LR-N16-0120

Subject: Salem Generating Station Unit 1 Compliance with March 12, 2012 NRC Order Modifying Licenses with Regard to Requirements for Mitigation Strategies for Beyond-Design-Basis External Events (Order Number EA-12-049) and Final Integrated Plan for Units 1 and 2

Attachment 2: Salem Generating Station Units 1 and 2 Response to NRC FLEX Audit Items

Figure 3: BDB FLEX Electrical Strategy (Page 3 of 3)

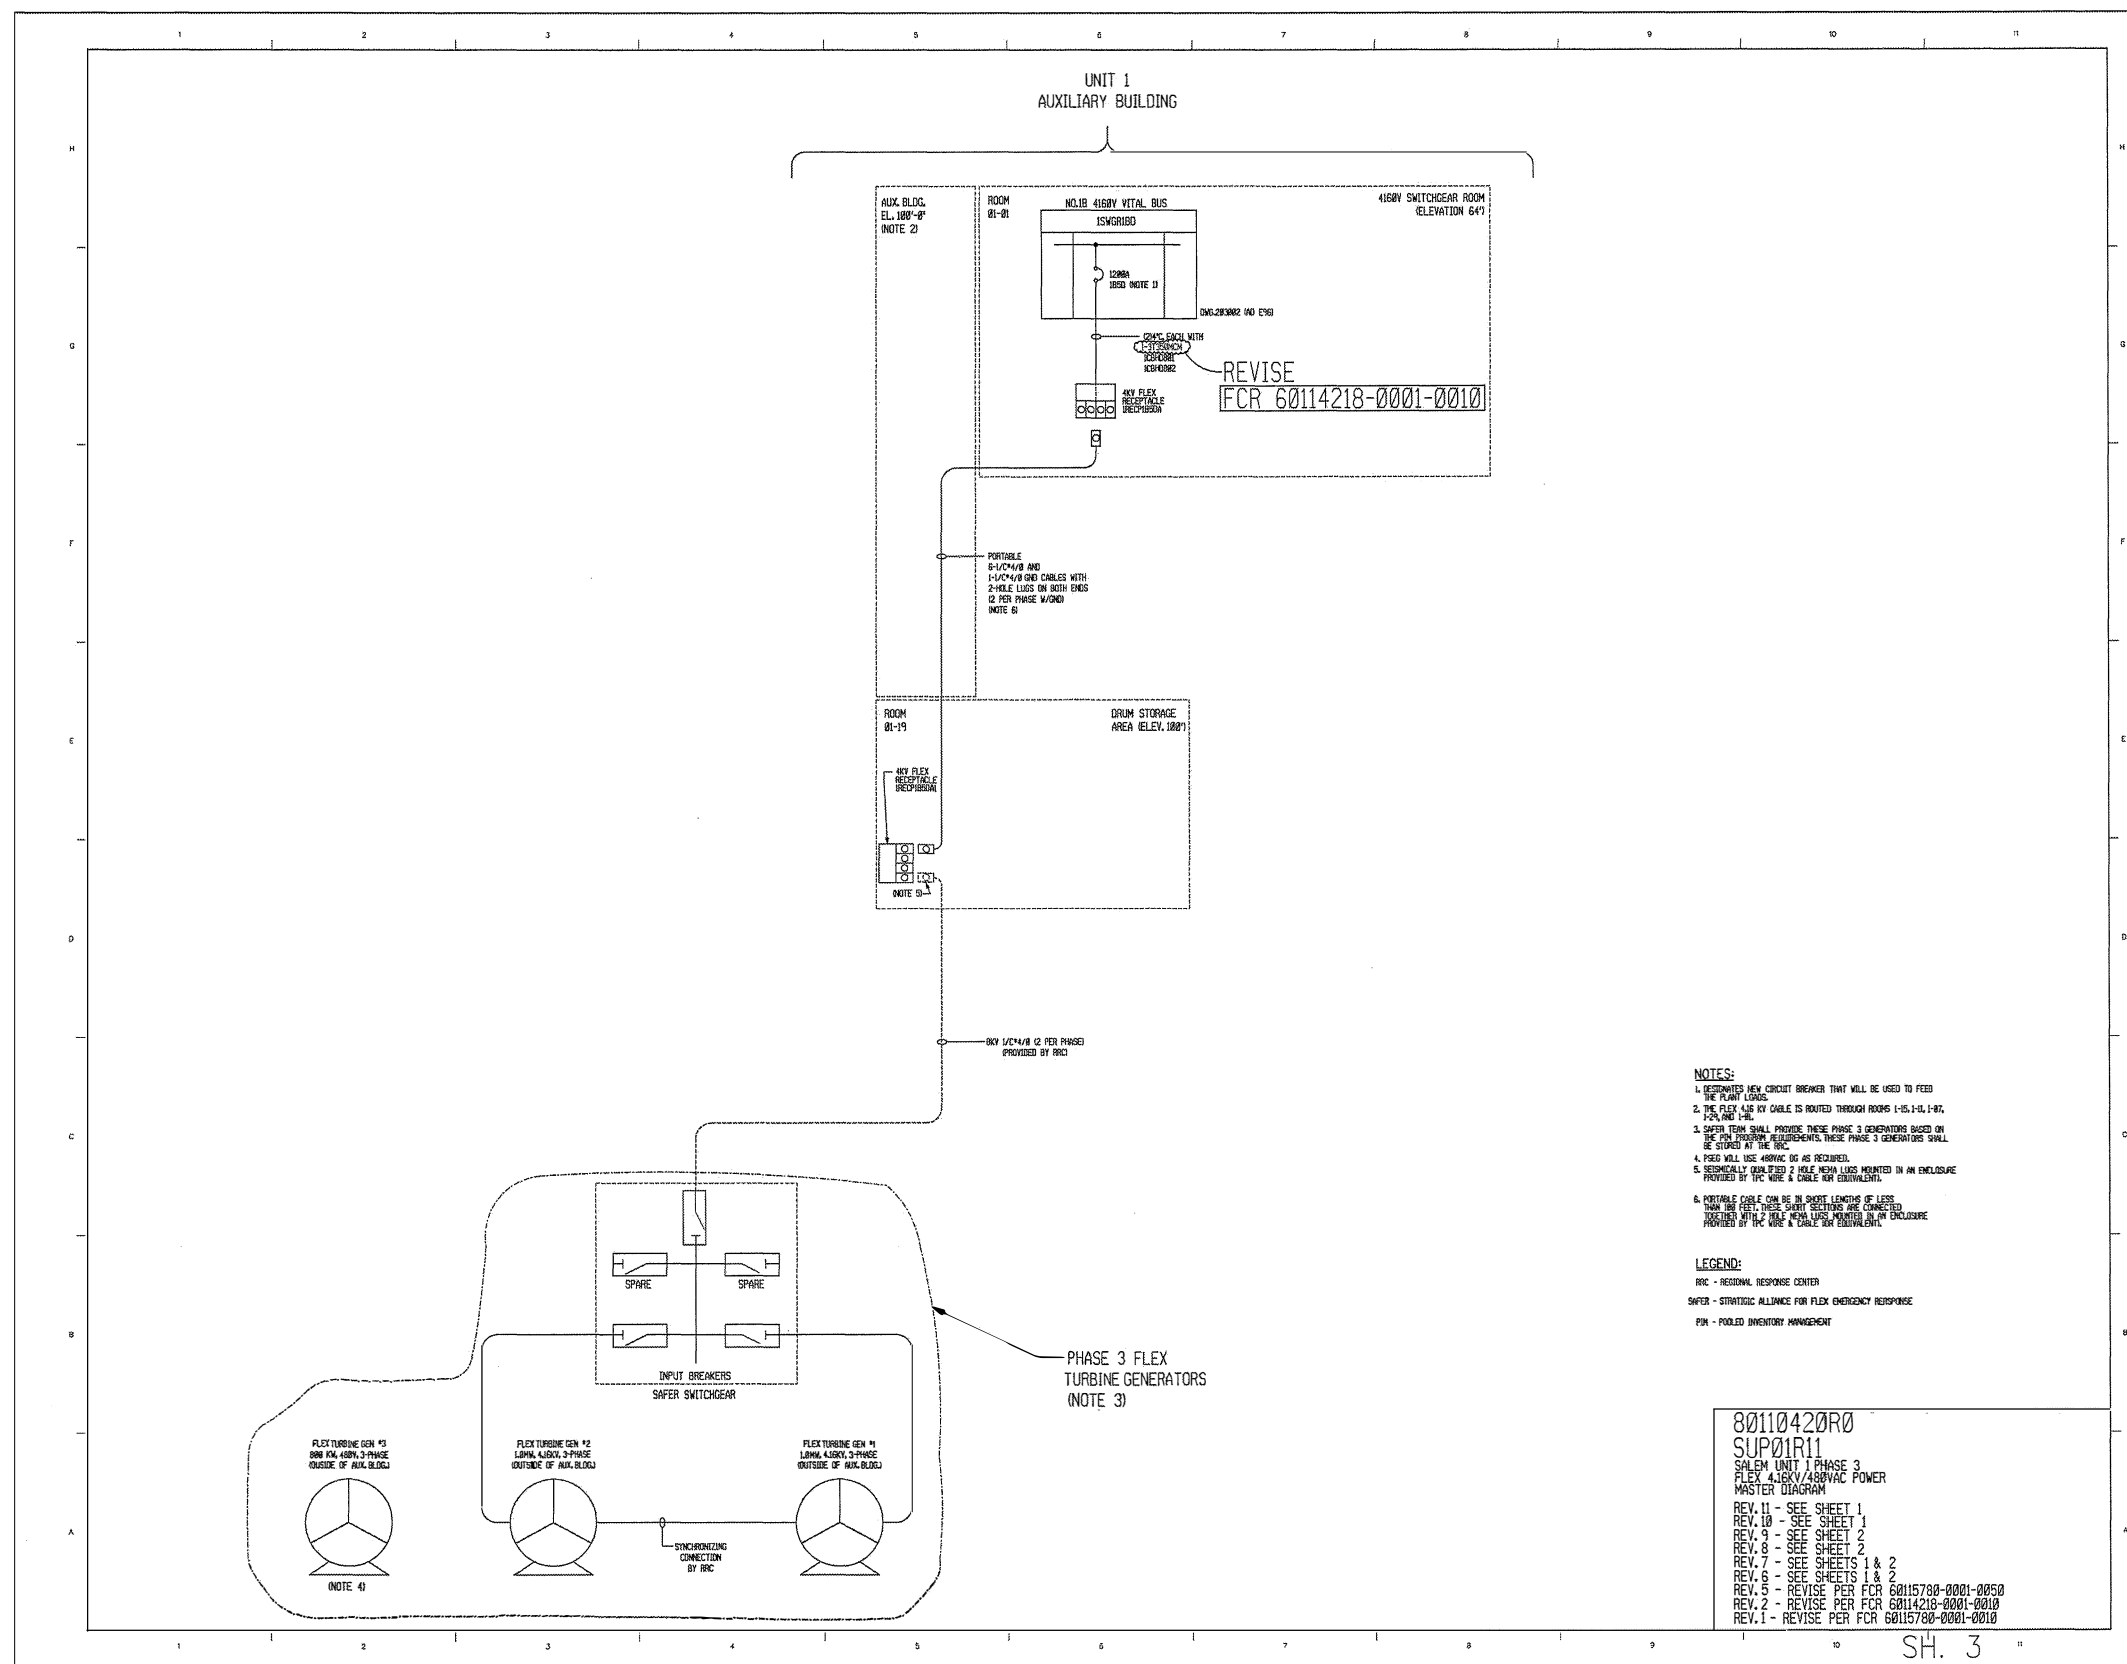
The licensee should provide the single line diagrams of the proposed electrical systems. As part of this item the NRC audit report (Reference 3) requested PSEG to address potential personnel hazards regarding the orientation of disconnecting blades in the FLEX power receptacles.

PSEG provided the single line diagrams as part of the audit process, and they are included in the enclosed FIP. PSEG provided the following information in response to the personnel safety aspect of this item:

- If the FLEX bus is the power source, the power cable to the disconnect is wired to the stationary side (non-blade side).
- If the plant bus is energized (normal configuration, no ELAP), the plant equipment is wired to the stationary side (non-blade side) of the disconnect.
